August 1, 2011
NRC3-11-0029

Subject: Detroit Edison Company Supplemental Responses to NRC Request for
Additional Information Letter Nos. 18, 42, and 57

**Attachment 1
NRC3-11-0029**

**Attachment 3
NRC3-11-0029**

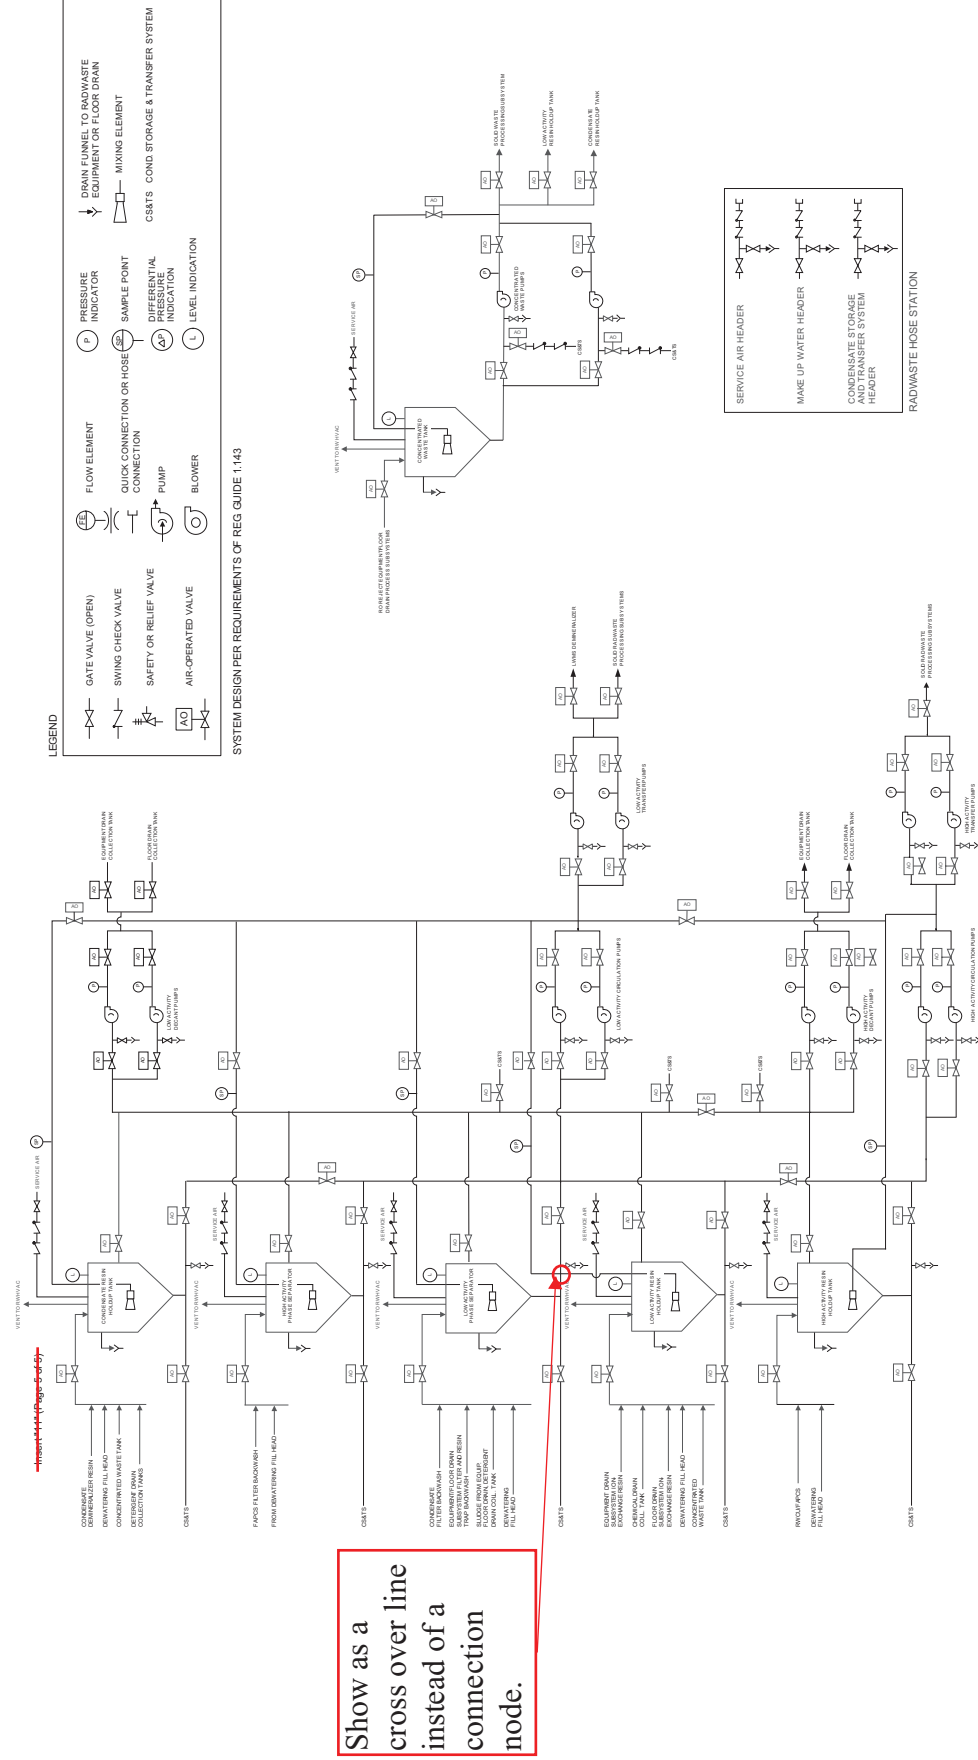
FSAR Section 11.4, "Solid Waste Management System [SWMS]," is incorporated by reference from the ESBWR Design Control Document (DCD), Revision 8, with Departure EF3 DEP 11.4-1. In Revision 3 of Section 11.4, Departure EF3 DEP 11.4-1 indicates changes to system component capacities for the SWMS, and includes Figures 11.4-1R and 11.4-2R, and Tables 11.4-1R and 11.4-2R. Figure 11.4-1R includes the revised system process diagram.

The proposed redesigned solid waste management system included the revised system process diagram in Figure 11.4-1R. However, the process diagram shows pumps in series in two places, with no holding tank or other equipment separating the pumps. This is shown for the:

- 1) Reactor Water Cleanup System (RWCU)/Fuel and Auxiliary Pools Cooling System (FAPCS) – the top process line, showing the high activity circulation and high activity transfer pumps, and*
- 2) Condensate Filter Backwash Drain/Equipment-Floor Drain Subsystem Filter Backwash Drain/Dewatering Fill Head – the lower process line, showing the low activity circulation and low activity transfer pumps. These pumps are shown as tandem units in parallel but the figure does not show if these pumps provide redundancy since they are lacking isolation valves.*

Additionally, the figure appears to be incomplete, in that the detail of the diagram is not sufficient for the NRC staff to fully evaluate whether the system processes are consistent with the regulatory position in Regulatory Guide 1.143 and Branch Technical Position 11-3.

It is not clear from this figure how these pumps are meant to operate, since dual pump units in series may be prone to cavitation. Please provide additional clarifications on the system operation and on the use of these pumps.

Detroit Edison provided a response to NRC RAI 11.04-4 (eRAI Tracking No. 5633) within Detroit Edison letter NRC3-11-0018, dated June 17, 2011 (ML11171A297), which included discussion of the Fermi 3 solid waste management system process flows. As discussed in a conference call with the NRC staff on July 14, 2011, further information to support this discussion is provided here as a supplement to that response, specifically Figure 11.4-1R is to be revised to depict the process descriptions in the FSAR text and in Figure 11.4-2R more comprehensively.

The block diagram represented in Figure 11.4-1R, consistent with the ESBWR DCD, represents a level of system detail to illustrate typical process flows of the Solid Waste Management System (SWMS) and is not intended to illustrate complete SWMS system capabilities. Configuration capabilities for the SWMS are shown in Figure 11.4-2R. Fermi 3 FSAR Figures 11.4-1R and 11.4-2R are currently consistent as Figure 11.4-2R shows that the system can be configured to support the flow paths depicted by Figure 11.4-1R.

As requested, FSAR Figure 11.4-1R will be revised to provide more system detail in the block diagram representation of SWMS, consistent with FSAR system descriptions and Figure 11.4-2R, as shown on the attached markups. In addition FSAR Figure 11.4-2R will be revised as shown on the attached markups.

The attached markups represent an update to FSAR Figure 11.4-1R to provide further SWMS system detail, as well as an update to FSAR Figure 11.4-2R.

Show as a cross over line instead of a connection node.
